10 Trinity Square, London
Addendum to Construction Method Statement
To be read in conjunction with Construction Method Statement, November 2008

10 TRINITY SQUARE, LONDON
ADDENDUM TO CONSTRUCTION METHOD STATEMENT
To be read in conjunction with Construction Method Statement, November 2008

Diagram 1 (Page 5 of 16)

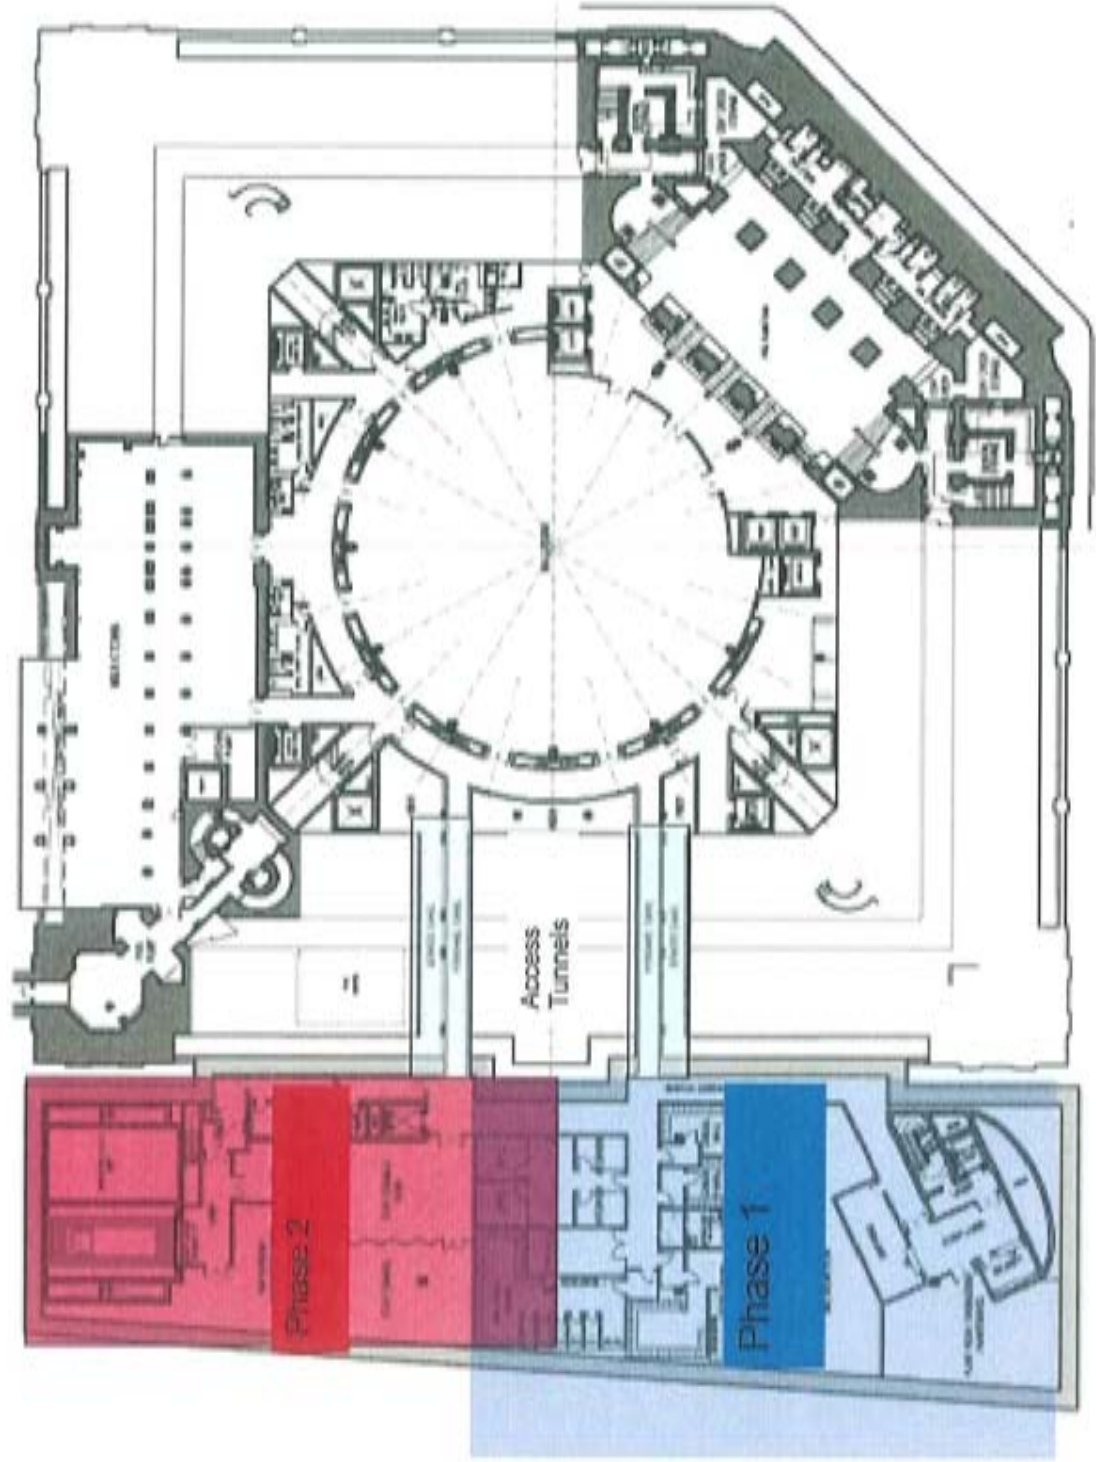
- Pavilion to the North: - This pavilion now houses the double vehicle lifts, which have been moved from the South Pavilion.
- Pavilion to the South: - The vehicle lifts are moved to the North as described above. The builders hoist has been relocated from the North to the South pavilion.

For the above items the only change to our Construction Method Statement, November 2008 is the revision of Diagrams 1, 2 and 3, which we enclose for inclusion in the planning amendment.
